ENGINEERING BULLETIN

Ref Document No.	EB18005	Issue No.	3
Subject	Exhaust Conditioner Float Update		
Release Date	23 rd October 2018

Purpose – Advise COALTRAM® owners/operators of an update to the design of the exhaust conditioner static water level float (PPK part number **5520000070**). Also advise of an update to the float and arm as used in the exhaust conditioner low water shutdown sensors (PPK Part number **5520000058**).

Figure 1 – Original vs Replacement Float

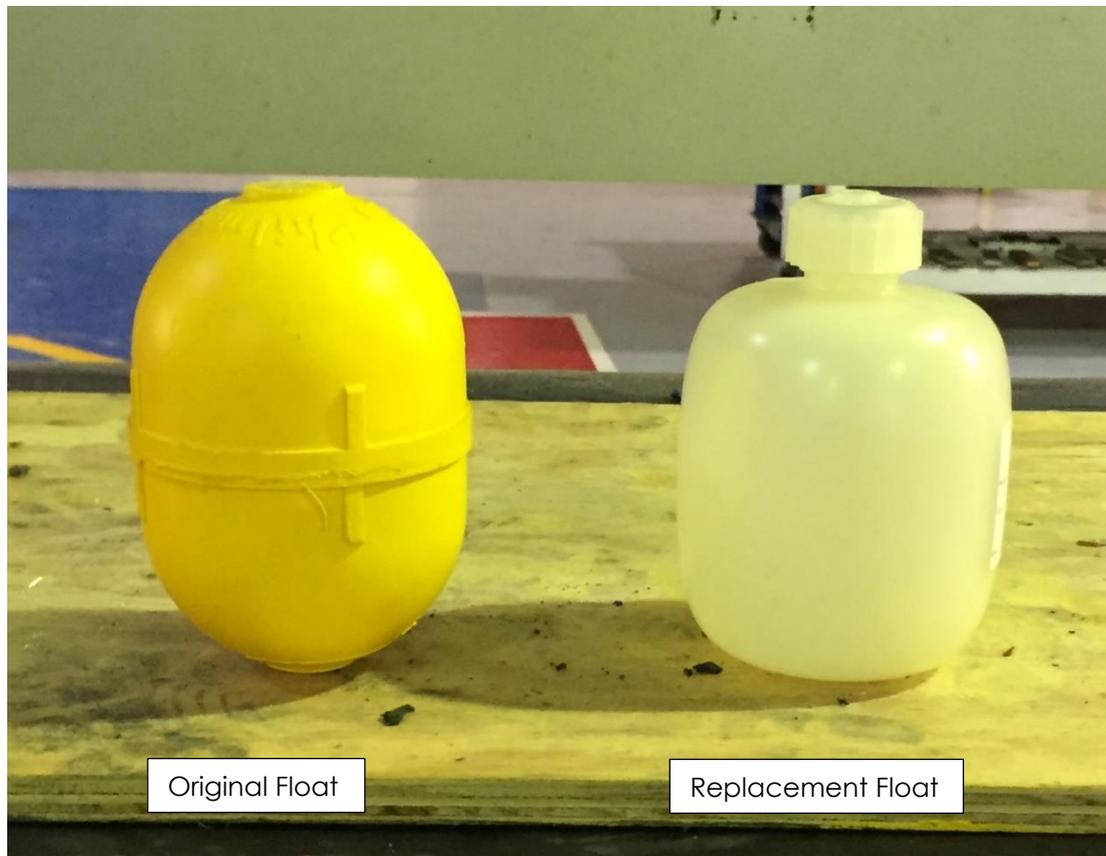
In May 2018 PPK was advised by our supplier that manufacture of the existing float used in PPK's exhaust conditioner low level shutdown sensor (PPK Part Numbers 5520000070) has ceased. A direct replacement float to fit on the existing float arm could not be found. PPK has determined that a modified float arm to accommodate the replacement float from the manufacturer is the most suitable option. Testing was carried out to ensure that the new float and arm design have negligible impact on the Exhaust Conditioner Level sensor function, and that the requirements of the DES registration are still met.

Owners and operators should be aware that the exhaust conditioner static water level float (PPK P/N **5520000070**) will now use the new float design. The static water level valve and arm have not been changed.

Figure 2 - Old vs. New Float Arm Design

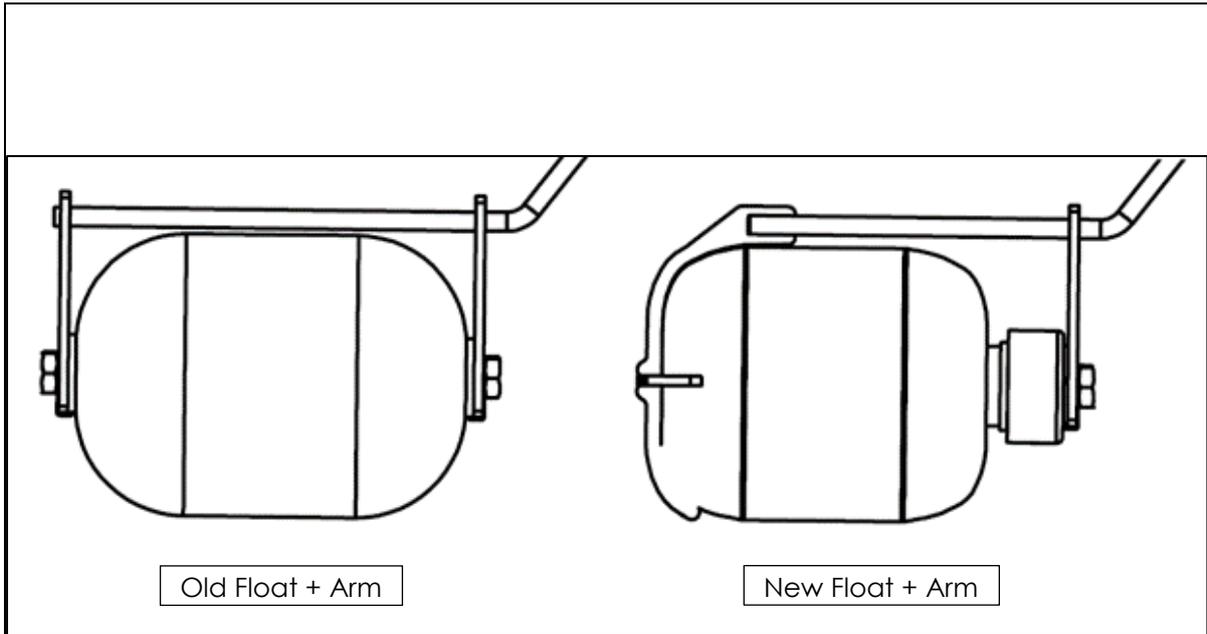
The new float can be seen to weigh slightly more than the old design, while maintaining approximately the same internal volume. The float weight increase has been counteracted with the float holder mass being reduced from 110g to 94g, resulting in a zero net weight difference.

Customers should also be aware that the exhaust conditioner low water shutdown sensor (PPK Part Number **5520000058**) will now utilise the new float and arm design.

Figure 4 - Exhaust Conditioner Water Level After Automatic Shutdown

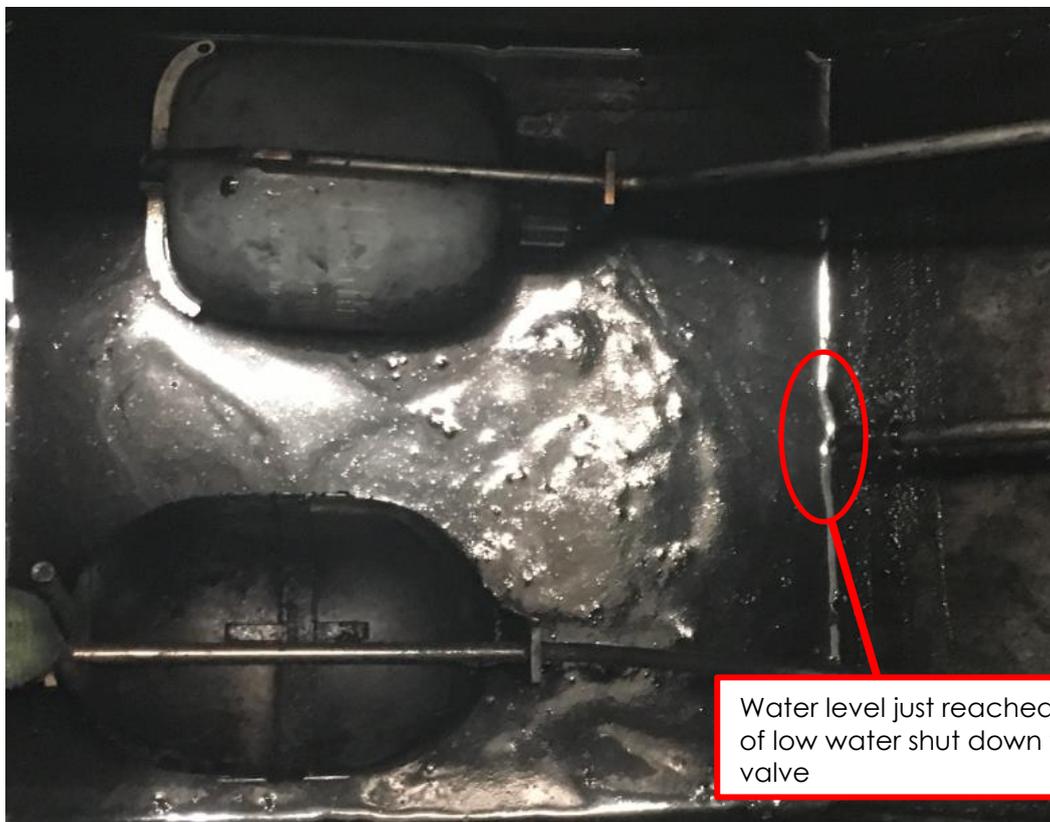
Test Summary: A level sensor with the new float and arm design was subjected to low water shutdown testing on a Coaltram CT10. The level sensor was placed in the outer position of the exhaust conditioner. The inner level sensor was tied high. The Coaltram was started and run at low idle, and the exhaust conditioner water was drained until the engine shut down. This was repeated a total of five (5) times. The objective of the test was to ensure that the sensor initiated an automatic engine shutdown before the statutory minimum water level was reached.

Results: In all five tests the machine automatically shut down before the statutory minimum water level was reached. This was confirmed by observing that water was still flowing from the low water shut down test valve after shutdown. On each occasion shut down occurred just as the water level reached the top of the low water shutdown test valve.

Figure 5- Exhaust Conditioner Old vs. New Floats Measurement

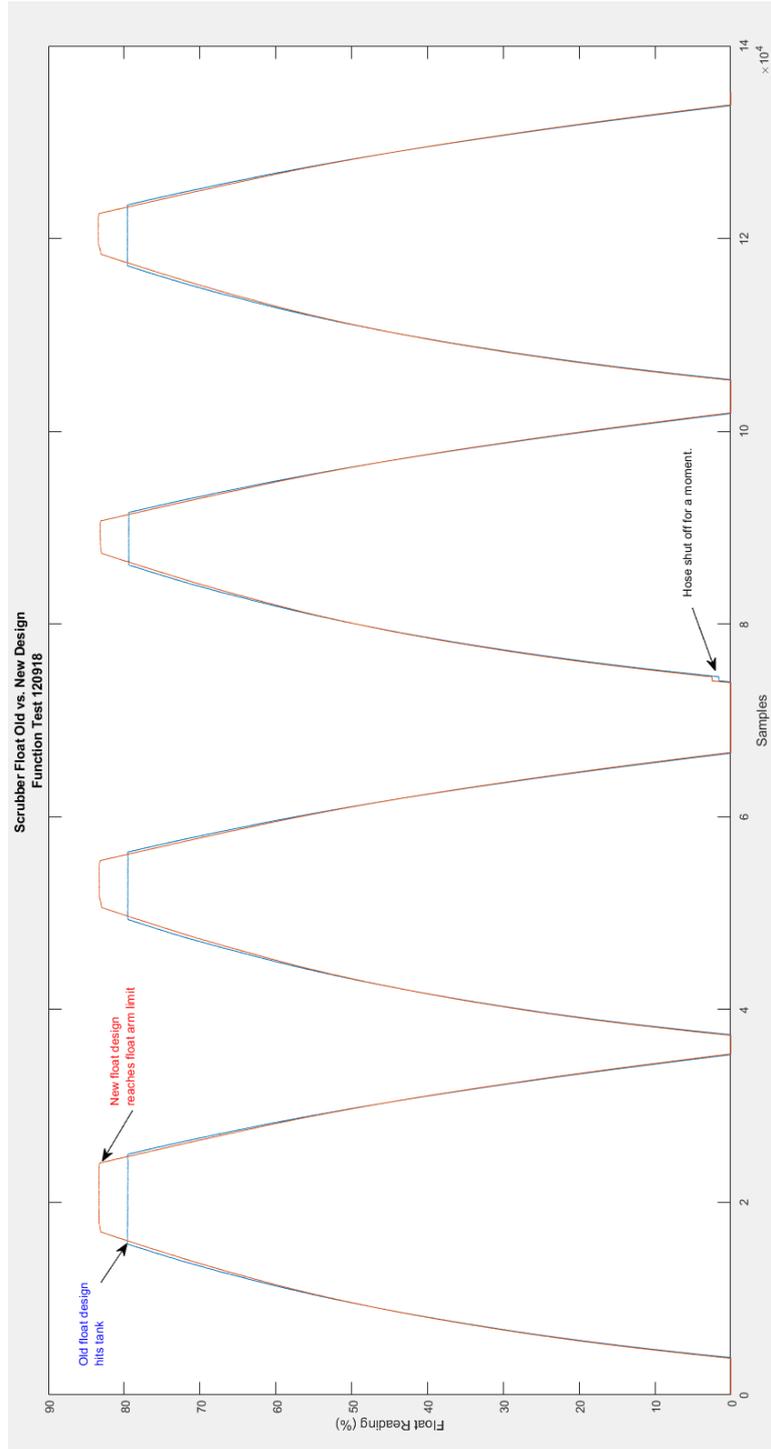
Test Summary: A float with the new arm and float design was tested alongside a float with the old arm and float design in a test exhaust conditioner setup. Exhaust conditioner was filled with water and drained a total of four (4) times. Readings were sampled from each sensor at a frequency of 25Hz.

Over the four fill/drain cycles the readings from the sensor with the new float design very closely matched those from the old float design. Noticeable deviation is observed at the upper limits of the float range, where the old float arm design hits on the tank deflector earlier than the new float holder. At water levels around the statutory low water shutdown point a maximum deviation of 0.6% was observed.
